Development Services

Status: Hold for Addit	ional Information		
Appeal ID: 20529		Project Address: 2623 NW 83rd PI	
Hearing Date: 6/12/19		Appellant Name: Eric Kirkewoog	
Case No.: B-019		Appellant Phone: 503-702-0949	
Appeal Type: Building		Plans Examiner/Inspector: Roza Malekzadeh	
Project Type: residential		Stories: 3 Occupancy: R-3 Construction Type: V-B	
Building/Business Name:		Fire Sprinklers: No	
Appeal Involves: Alte Change loft to mezzan	ration of an existing structure,other: ine	LUR or Permit Application No.: 19-157067-RS	
Plan Submitted Optic	on: mail [File 1] [File 2]	Proposed use: single famliy	
APPEAL INFORM	ATION SHEET		
Code Section	Section 325 - Mezzanines		
Requires	Existing "loft" drawing A16 to meet all requirements for a mezzanine R325.1, R325.2, R325.3, R325.4, and R325.5		
Proposed Design	Change status of existing loft (Drawing A16) to mezzanine. The existing loft is approximately 148 sq. ft. and the area below is in excess of 450 sq. ft (drawing 17). The clear height is 8' - 6" plus or minus, means of egress are met and openness requirements are met. (R325.1 - R325.5).

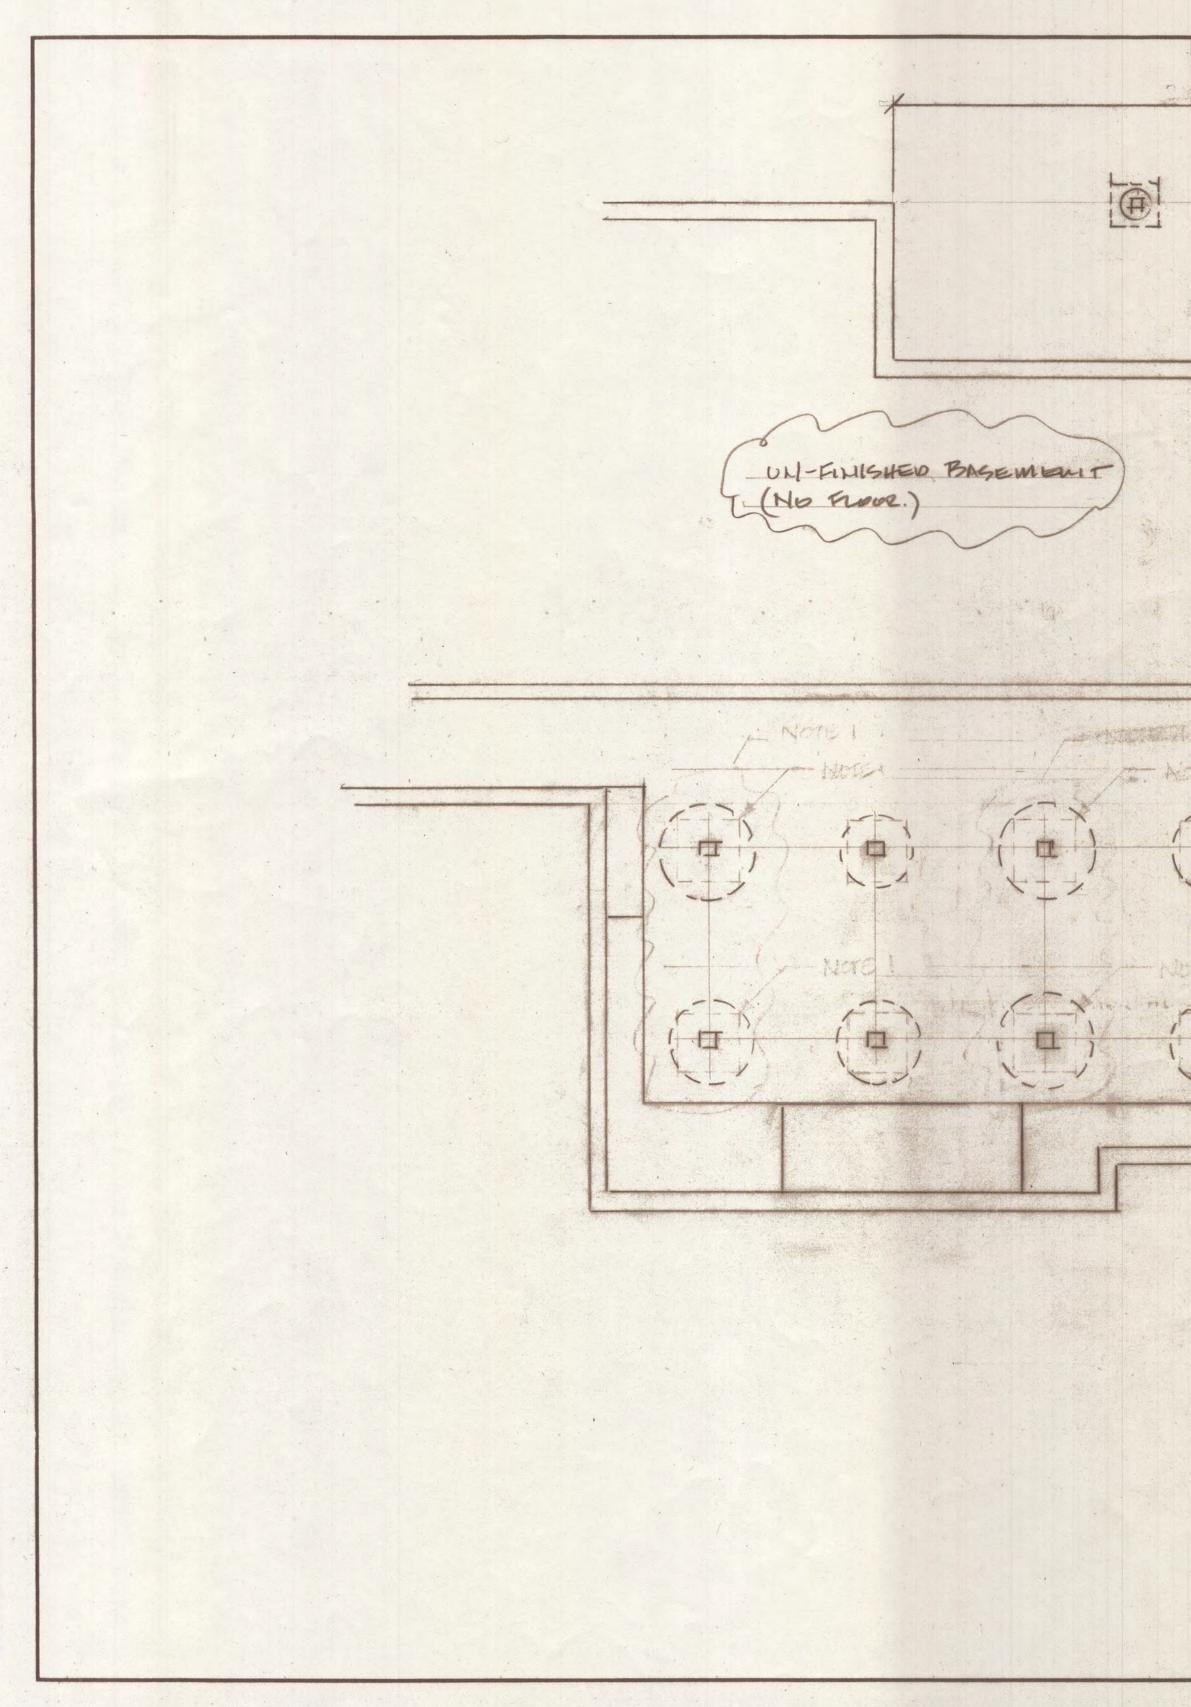
28'-0" Han Tacher Ditte NEW FOOTING 24" × 24" ×12" CONCRETE FOOTING. WITH REBAR AND SIMPSON HANGER FOR LOXLE PLEASE REFE TO STRUCTURAL DRAWING S20 A. A. 96 NEW FOOTING , SEE PETHILS ABOVE. FOOTINGS HAVE BEEN REDRAWL TO REFLECT 4'0" ALTURE ROUMD FOOTIME CONFIGURATION. Ø T NOTO: NATE IL ABRANTICAN FUERTHARS, 1211 FOUNDATION PLAN AREA BELOW GARAGE . SCALE: 41 APPROVED BY: DRAWN BY DATE: 3-11-19 REVISED 4-21-19 REV2 DRAWING NUMBER A7

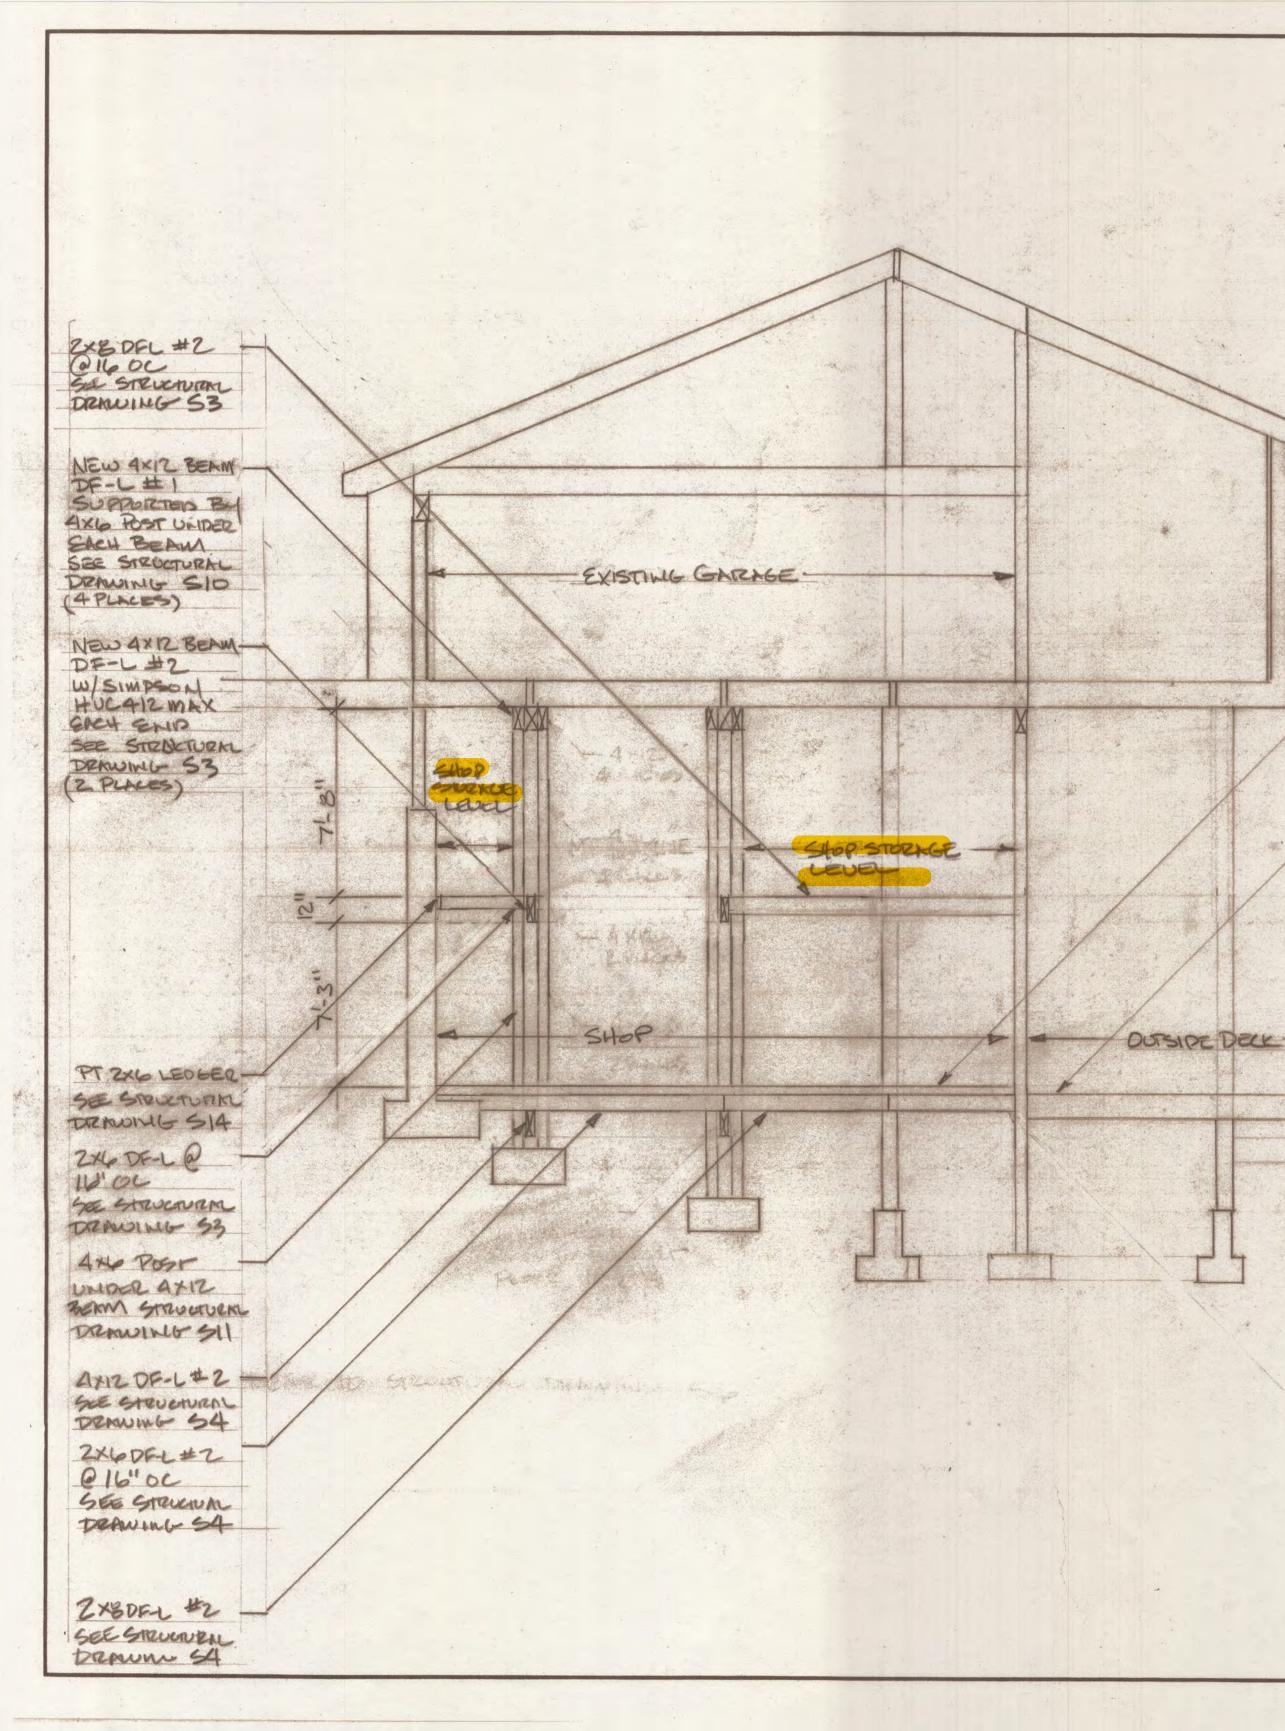
VILANK LOUSS STRUCTURE SUSSEMENTES STRUCTURERS TREADERS Compression Lebie. se all', le' l'or, l' des pares 7.0 LECTIONALS 3" CONICRETE TOPPING SUNB SEE STRUCTURING DRAWING # 58 PTZXIZ LEWFIZ #2 CIL'OL GEE Greveren Denout 55 15-0" AP ... senter FRAMMUM NOTES: 1. CROSS SECTION DRAWING REDONE WITH SECTION @ DIFFERENT LOCATION TO BETTER ILLUSTRATE THE DETAILS OF THE PROJECT 2. STRUCTURAL DIRAWINGS HAVE PETHIL OF CONSTRUCTIONS ANID HAVE SPELIFIC DRAWINGS CALLED OUT . CITY REVIEW & CONSTRUCTION 1 CROSS SECTION APPROVED BY SCALE: 4 = 1 DRAWN BYERICK DATE: 3-13-19 REVISED 4-21-19 Rave 5-19-19 REV3 DRAWING NUMBER AIZ

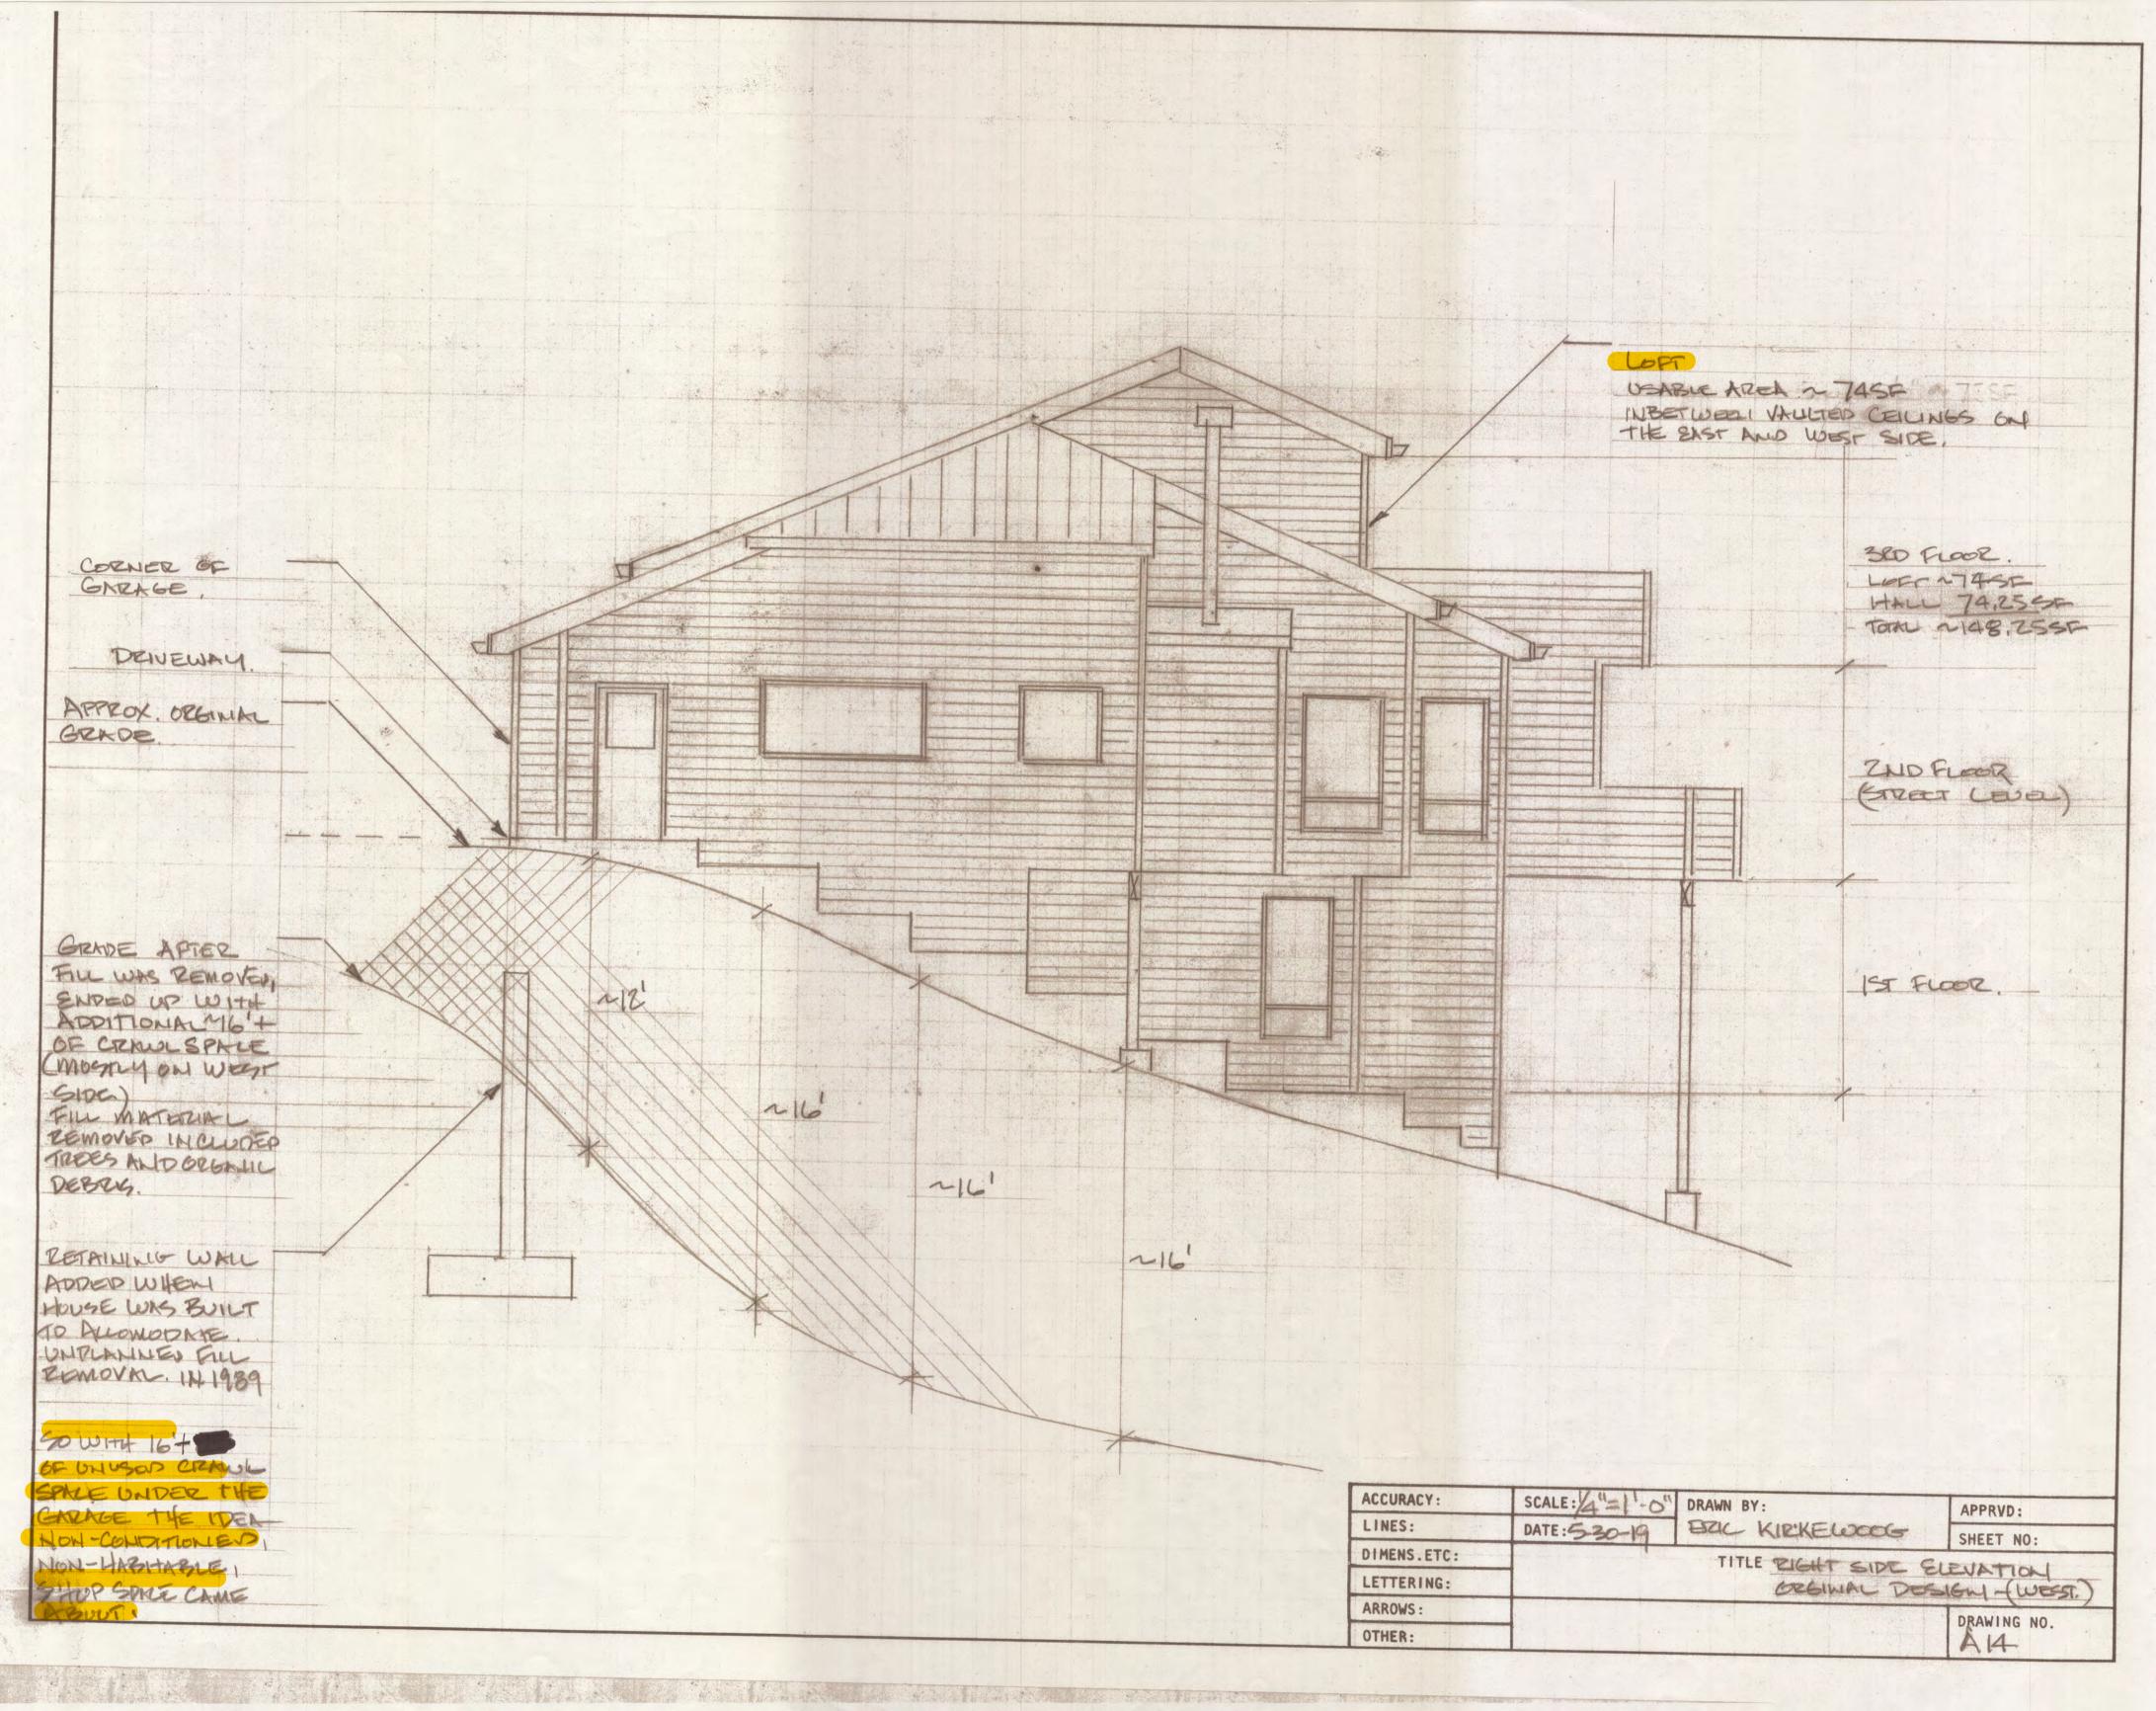
CONTOUR LINES (APPROX) -(2) COASTRE PINE (B" DIA) TRECTION OF SLOPE - (3) ASPEN (5-61/2" DIA) (3) CEDAR. (9-10" DIA) FLOWERING CHERRY (15" DIA.) CYPRESS (BHDIA) - EXISTING UPPER DECK. EXISTING LOWER DECK - TEMPORARY SEDIMENT (SILT) FEMICE, INSTALLED PER SEDSION CONTROL MANJUAL DETAIL DIZALUING 43-A NELE FOOTING (SEE A7) CEDAR (ID"DIA.) - NEW DEAL (SEE AID) -NEW FOOTING (SEE A7) CEPAR (11" DIL) -NEW STAIRS (SEE 49) ELM (6"DIA) DOUGLOS FIR (22"DIA) JAPANESE MARLE (3"DIA) LO SCIBAL OK (?) (2"DIA) 14'0' Pob waso G'6' SIDE OF HOUSE TO PROPERTY LINE EXTENSIONS & REQUIRED SETBACKS 200" VIME MAPLE, (3"DIA) - ELENTION' ~ 969 (5) YOUNSPELICE (4"-5"DIA) 33.10,220C2F VENUS DOGWOOD (I"DIA) STAT EXISTING DEIVEWAY (CONCRETE ON DECK) ELEVATION JAPANESE MAPLE (4" PIA) CORE NO SITEWALK) EXISTING RETAINING WALL 1972 EXISTING DRIVE WAY (CONCRETE ON DIRT.) VINE MARLE. (3" DIA) EXISTING DECK (TIMBERTELH) PROPORED NEW UNHEAPED SHOP AREA -(GOE A9 & AID) UNDER EXISTING GARAGE. 24 HOUR EROSION CONTROL COTACT. PLANNING & ZONING ERIC KIRKE WOOG (IDWE OWNER) SCALE: 1 = 200" APPROVED BY DRAWN BY EUC C DATE: 5-15-19 REVISED 503-702-0949 (CEL) DRAWING NUMBER A13
